City of Lawrence

Planning & Development Services

Attachment: Table of Comparisons: **FDP-02-03-09**: Revised Final Development Plan for The Oread, located at 1200 Oread Ave. Submitted by Paul Werner Architects, for Oread Inn, LC, property owner of record.

Approved FDP- Building Height

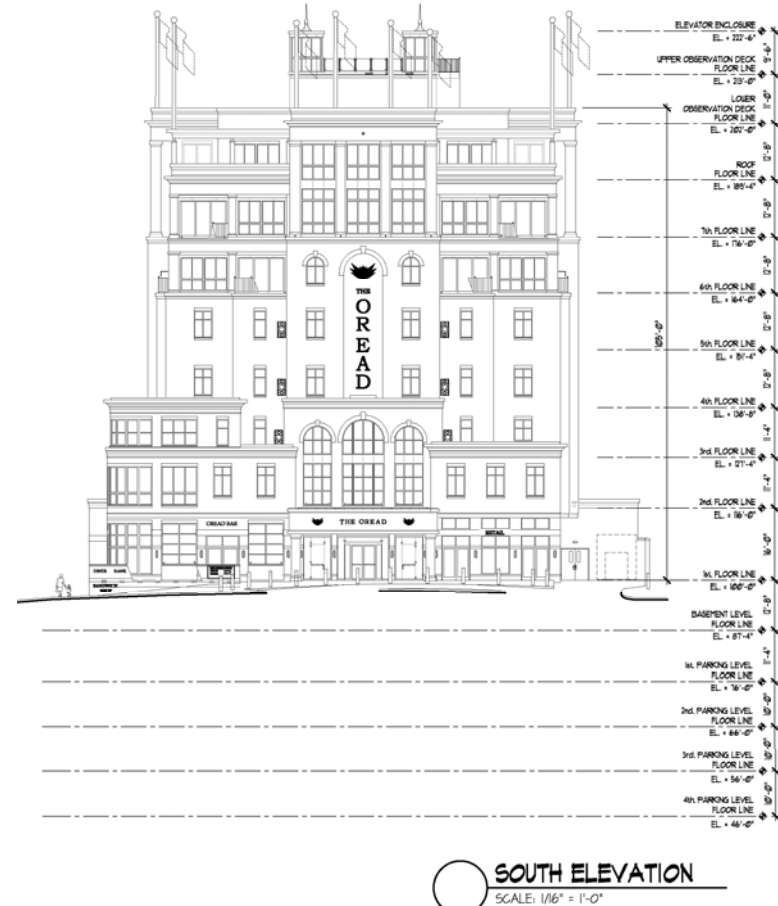
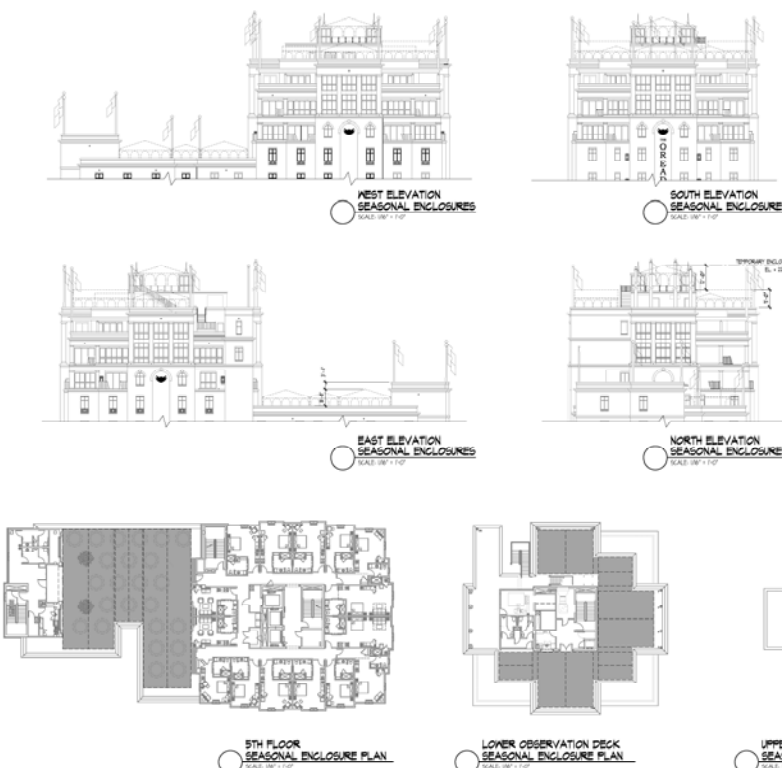
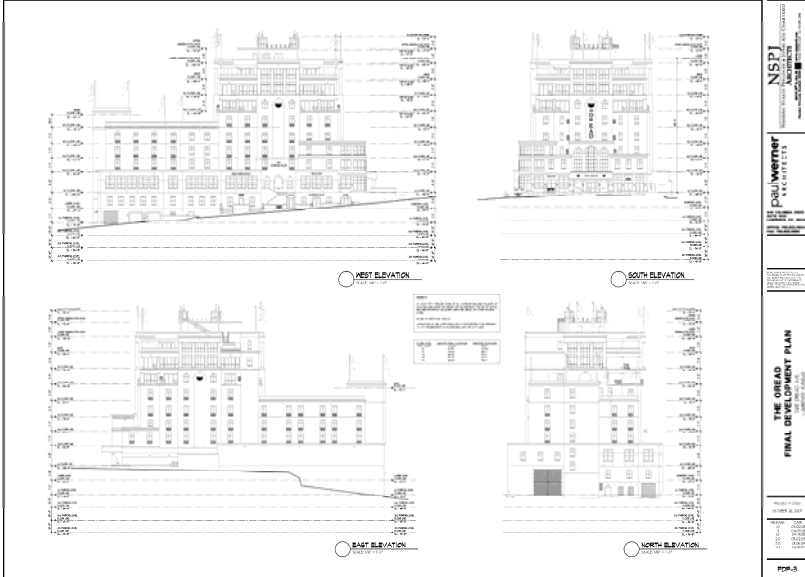
Maximum base line height of the building was restricted to 105' applied to the front face from the "adjacent grade to the to the top of the 7th floor deck parapet". The observation deck floor line was restricted to 114' in height. An additional 9 feet are added to the structure referred to as the upper deck elevator enclosures.
